STAFF REPORT

TO: Planning Commission
FROM: Ben Prchal, City Planner
AGENDA ITEM: The Legacy at North Star Third Addition – Easement Vacation(s) and Final Plat and PUD Plans
REVIEWED BY: Ken Roberts, Planning Director

To: Ken Roberts, Planning Director	Re: Legacy at Northstar 3rd Addition – Final Plat
Cc: Chad Isakson, P.E., Assistant City Engineer	Engineering Review Comments
From: Jack Griffin, P.E., City Engineer

To: Ken Roberts, City of Lake Elmo Planning Director
From: Lucius Jonett, Wenck Landscape Architect
Date: February 19, 2020
Subject: City of Lake Elmo Landscape Plan Review
Legacy at Northstar 3rd Addition, Review #1

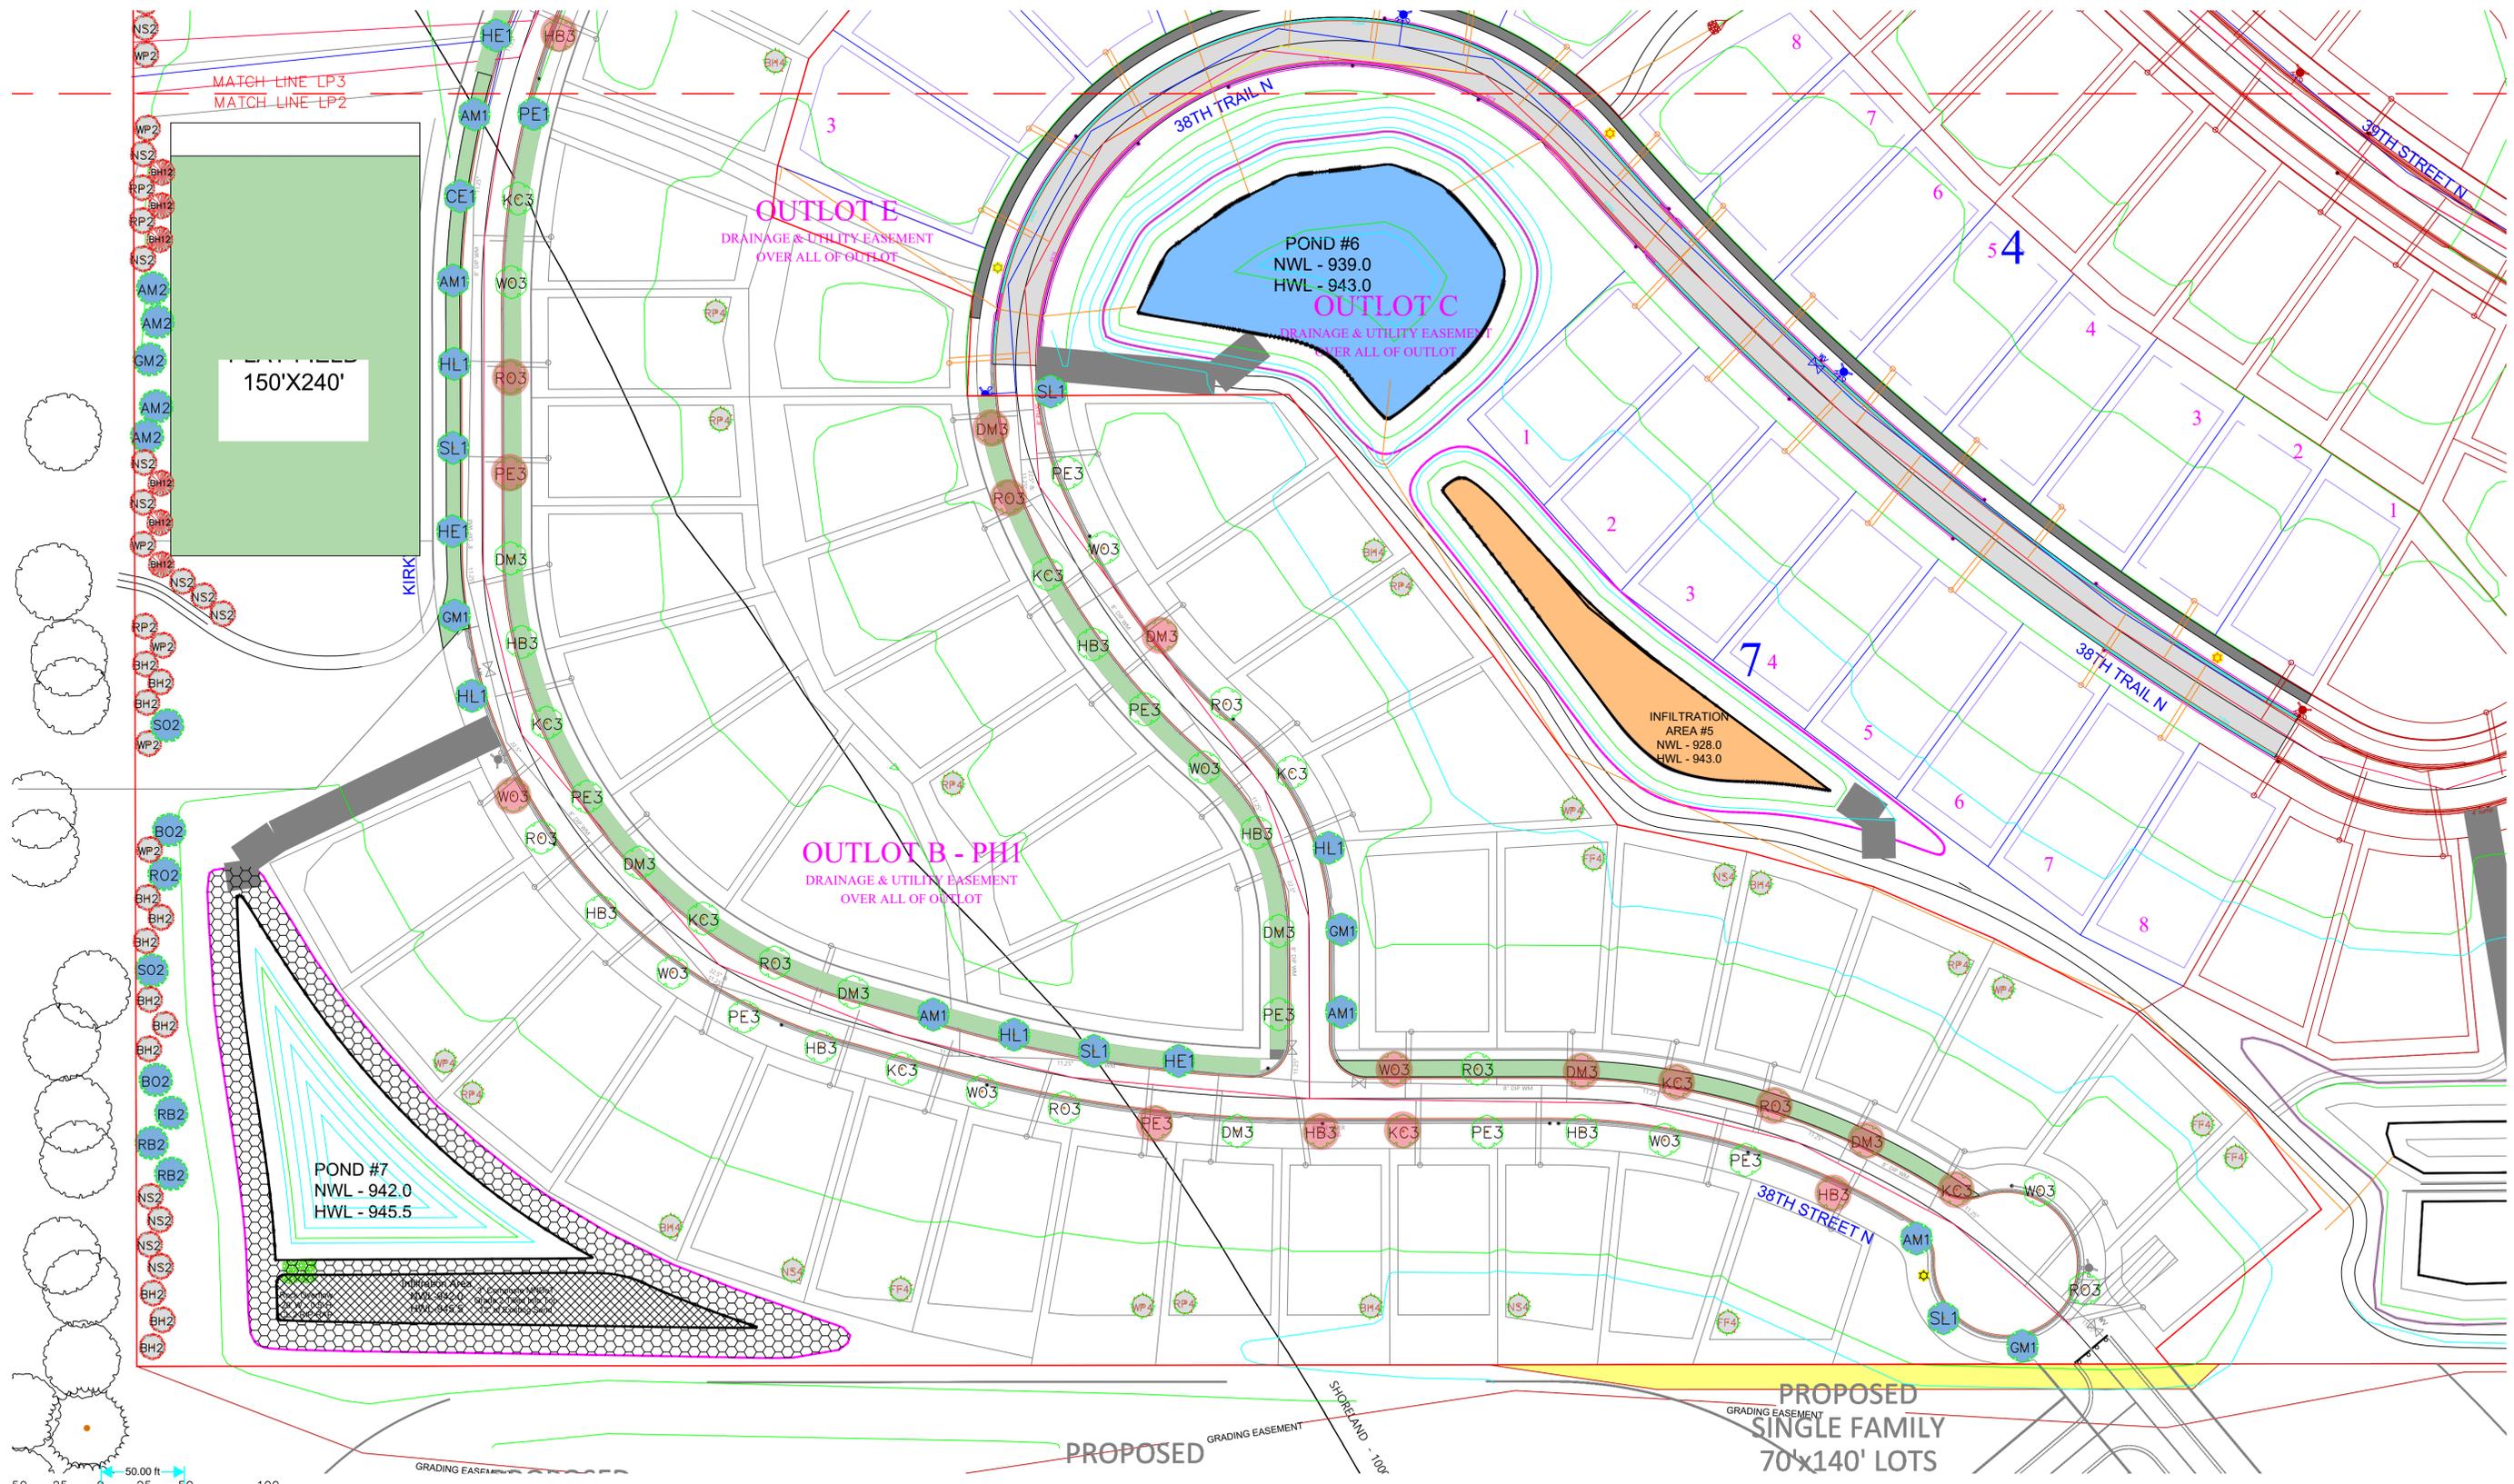
3. There are several trees drawn within 10' of the utility service lines to the properties. See attached figure showing conflicts. It is noted on the plans that trees are to be 10' away from trunk to utility pipes in case symbols depict a location too close to utility services to homes on the plan.

1. Submit a revised landscape plan including the missing driveway pavements, stormwater utilities, and easement lines for conflict review. And adjust the location of the greenbelt screening plantings to be outside of the 10' small utility setback/easement from all property lines.

PHASE 3 LANDSCAPE PLAN
 LEGACY AT NORTHSTAR
 GONYEA

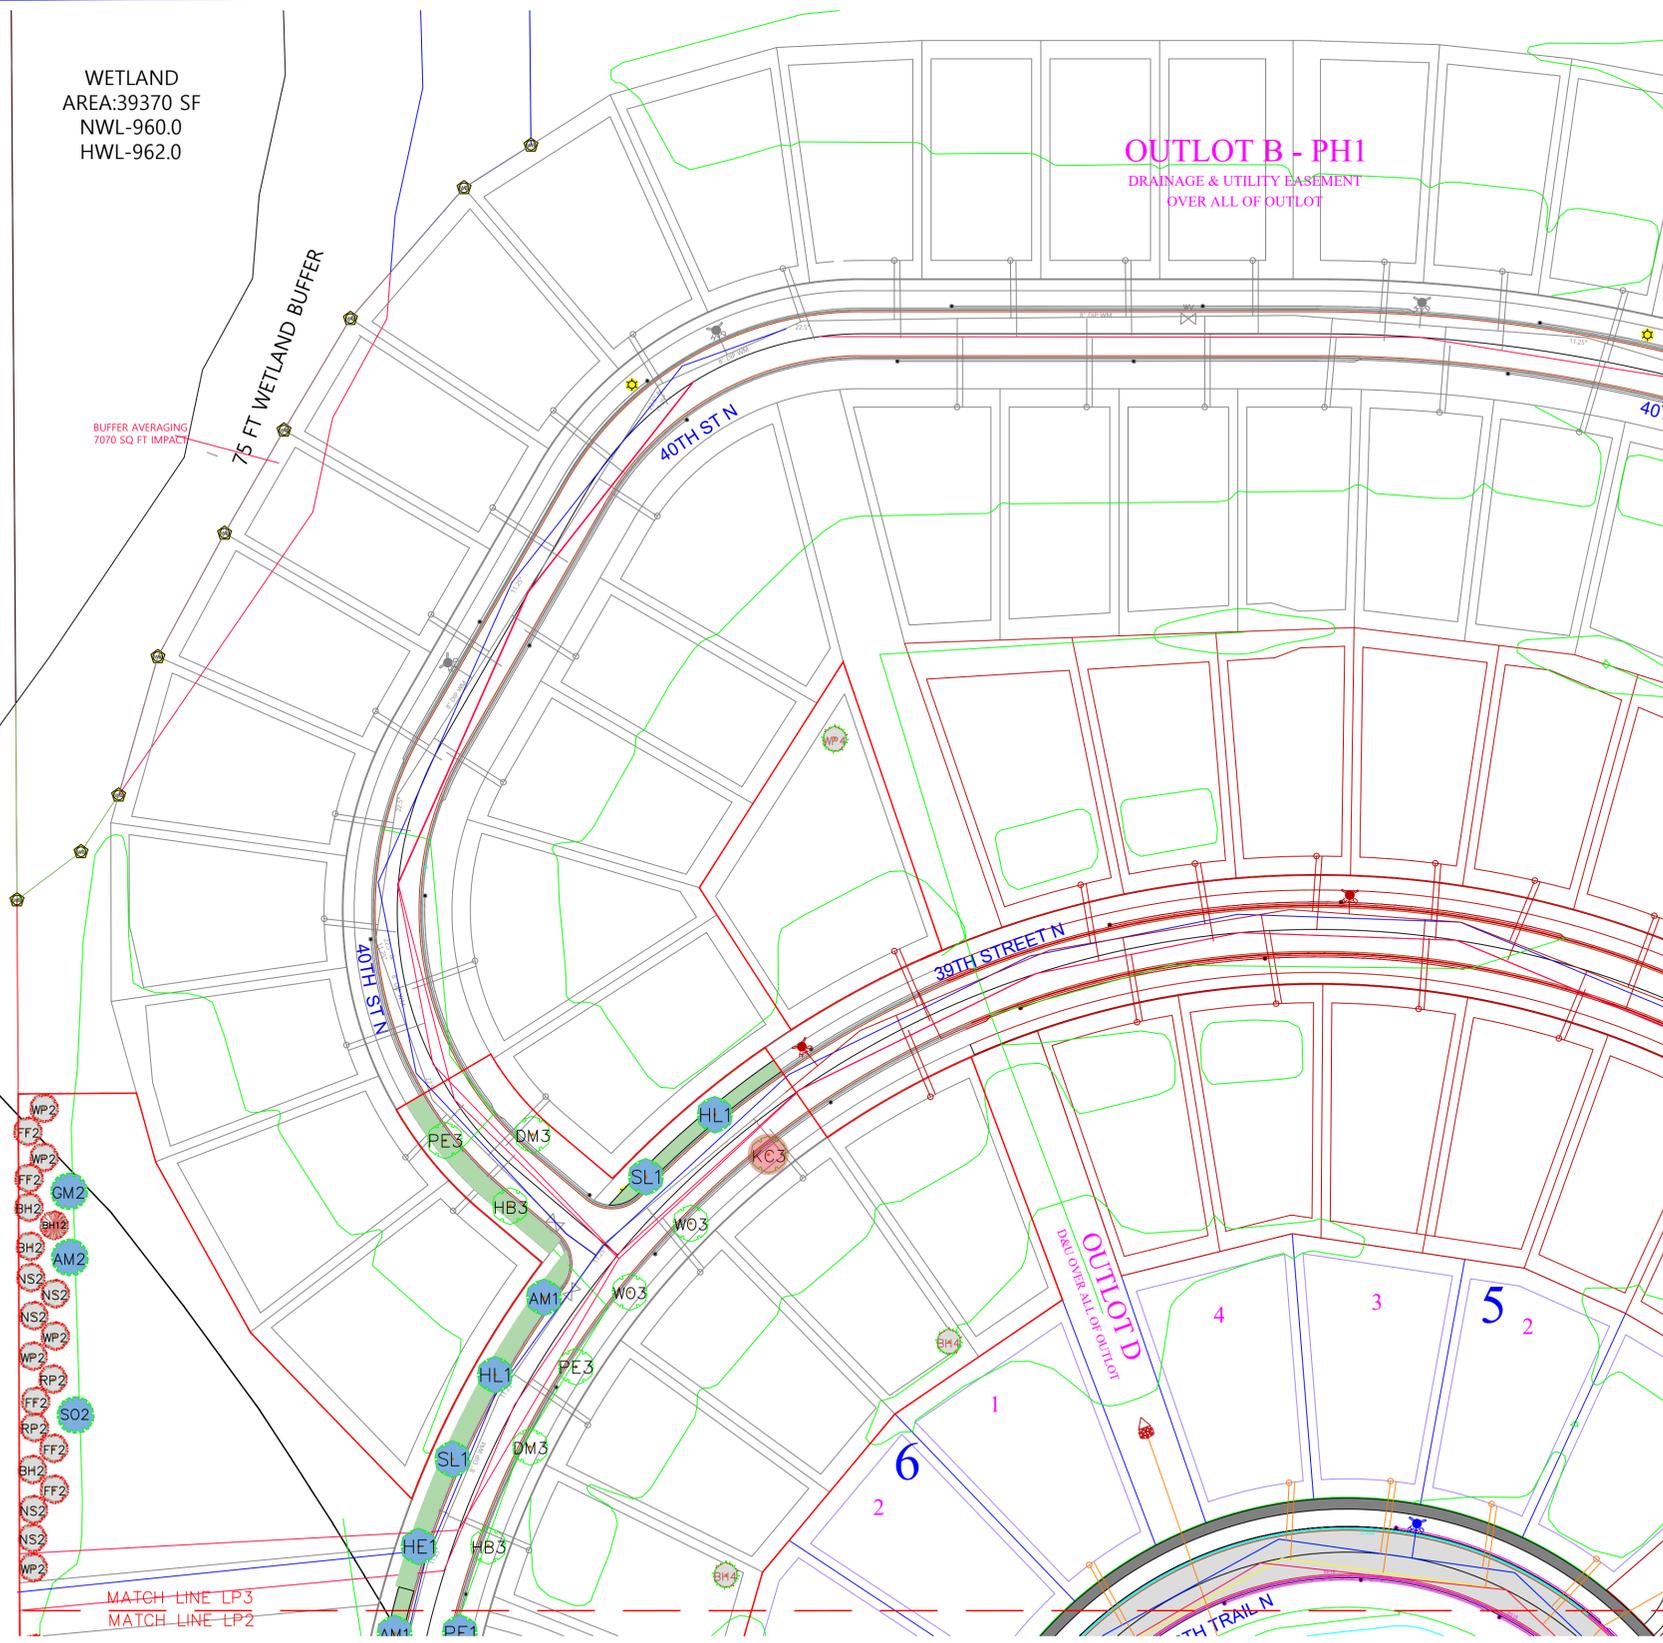
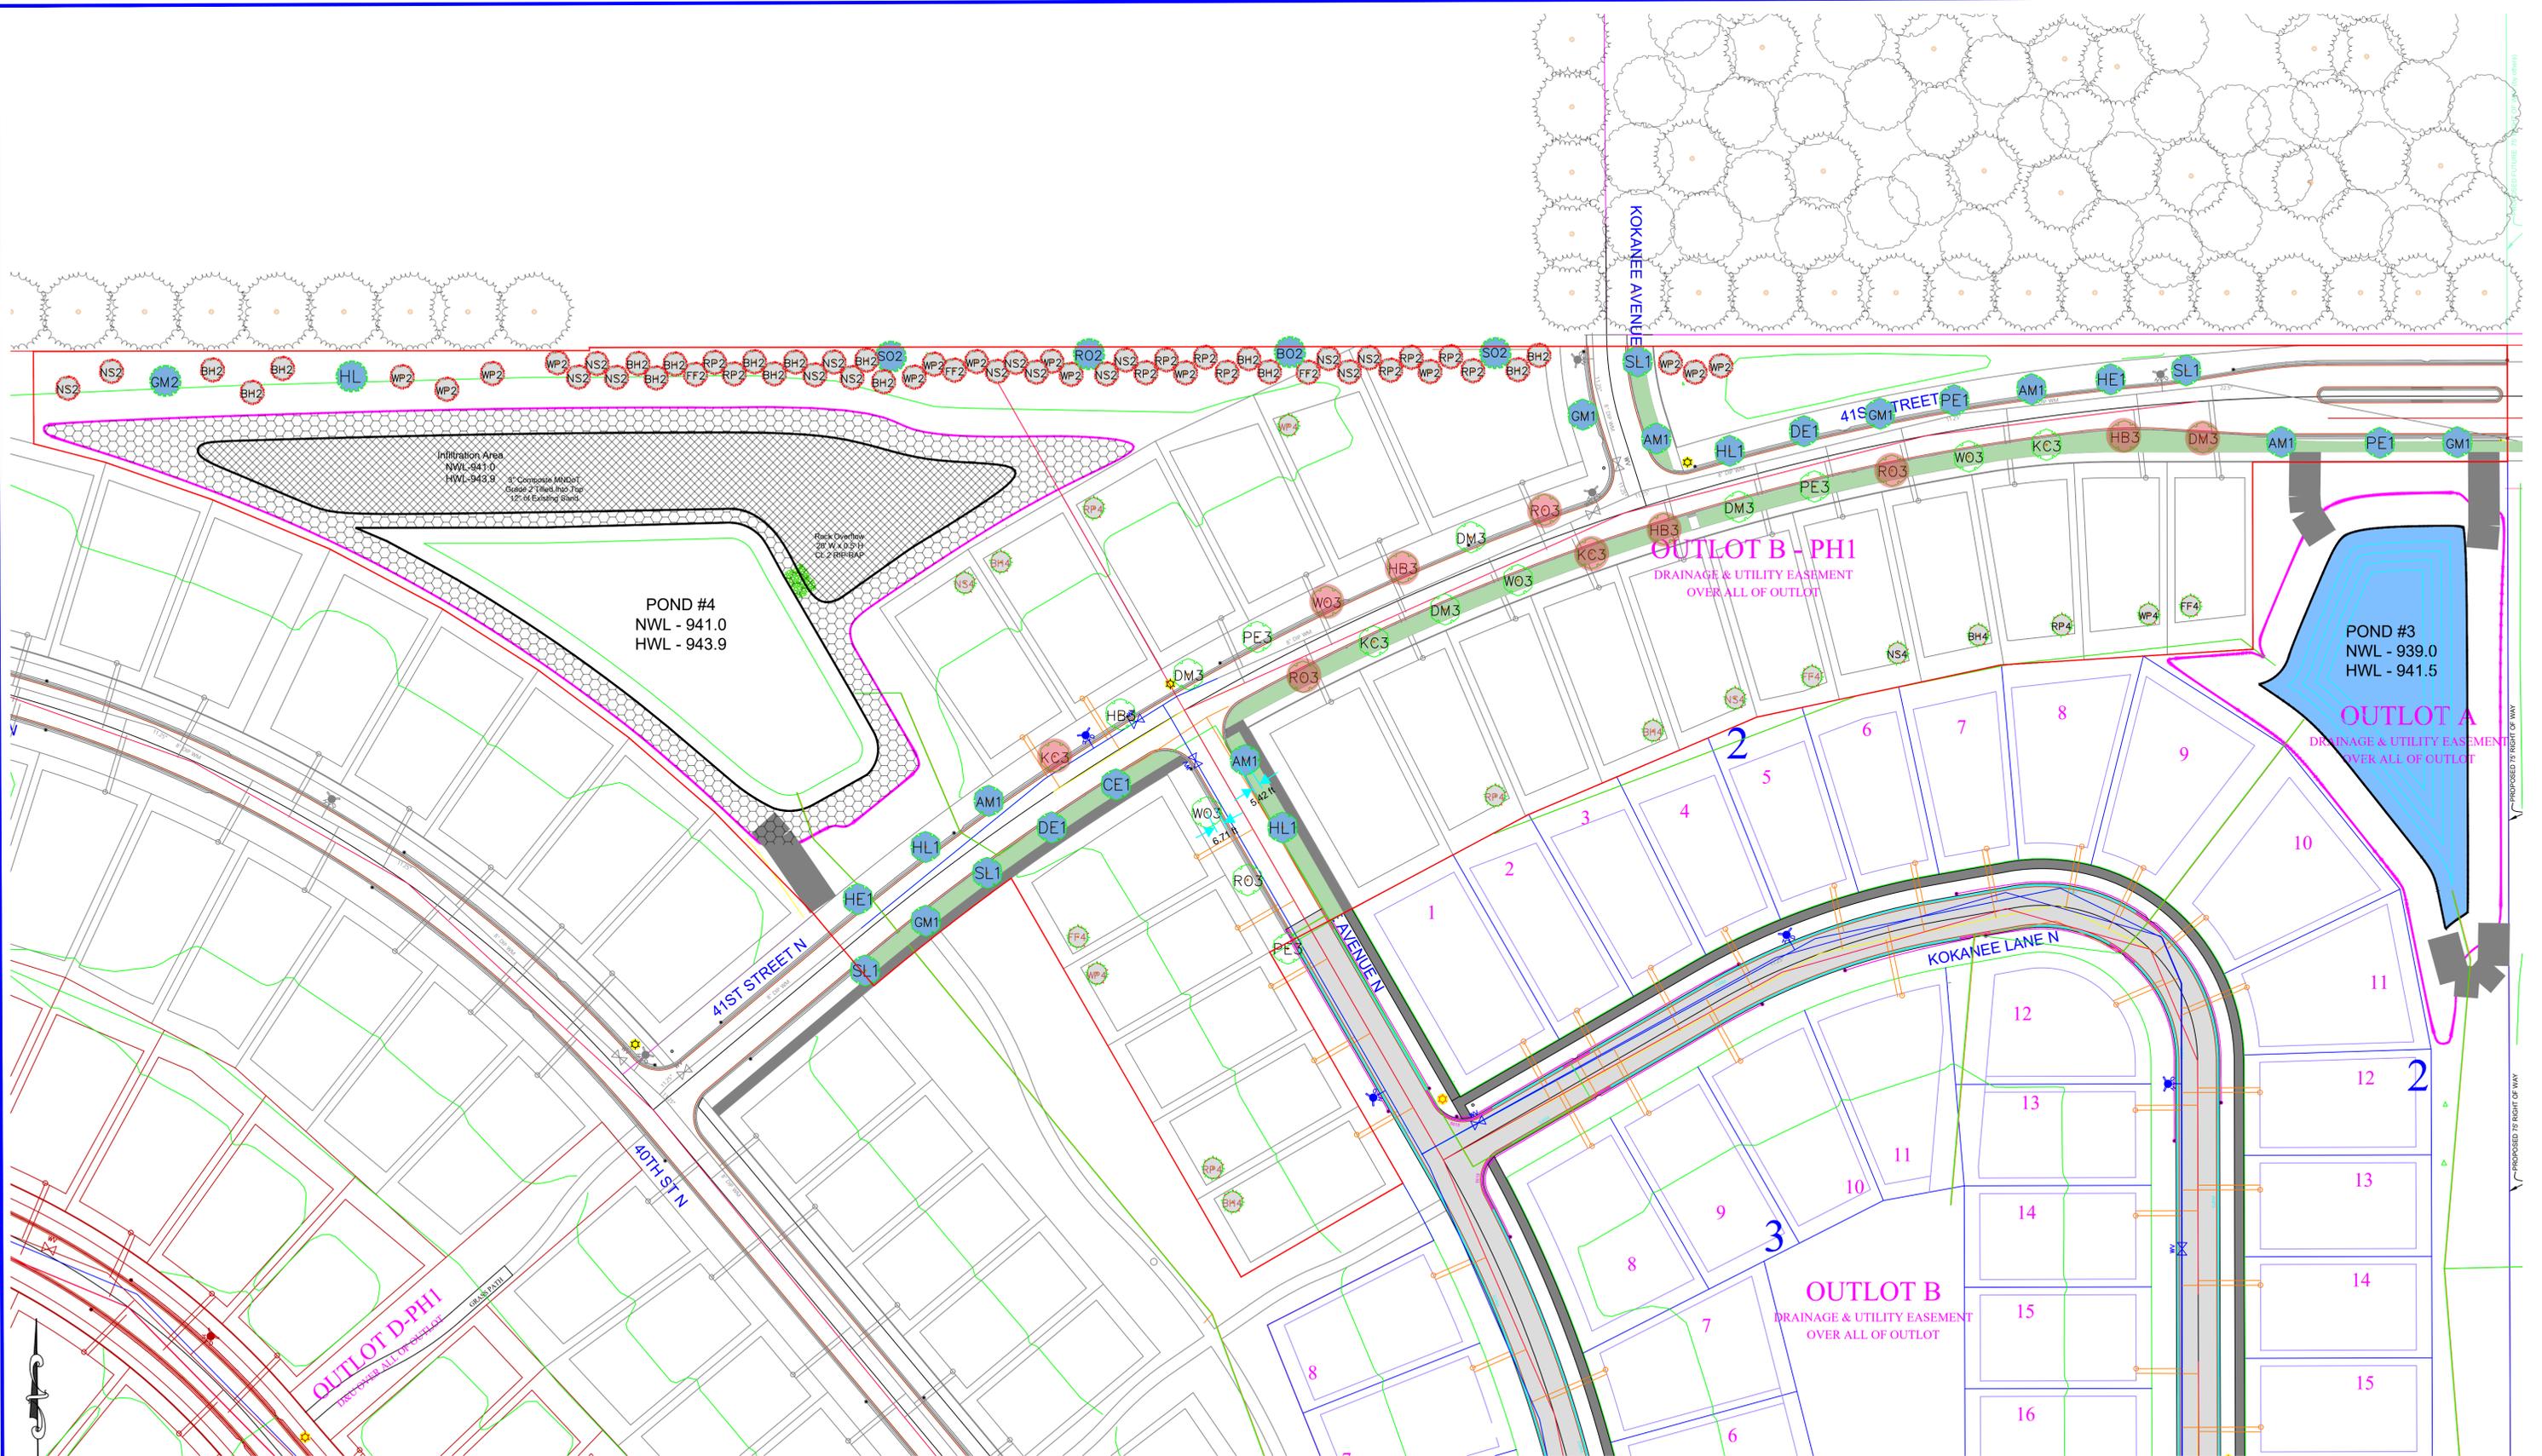
- A. A landscape plan has been submitted that **does not include** all requirements.
1. Driveway pavements **are not** shown on the landscape plan to review for tree placement conflicts.

2. Stormwater utilities **are not** shown on the landscape plan to review for tree placement conflicts.
 3. Property lines and easements, including 10' small utility setback/easement from all property lines, **are not** shown on the landscape plan to review for landscape placement conflicts.

- i. No deciduous tree trunks, evergreen tree mature driplines, or shrubs are allowed in the easement areas.
- B. The landscape plan **does not** meet the landscape layout requirements.

1. Driveway pavements, stormwater utilities, and easement lines, including 10' small utility setback/easement from all property lines, **are not** shown on the landscape plan to review for landscape placement conflicts.
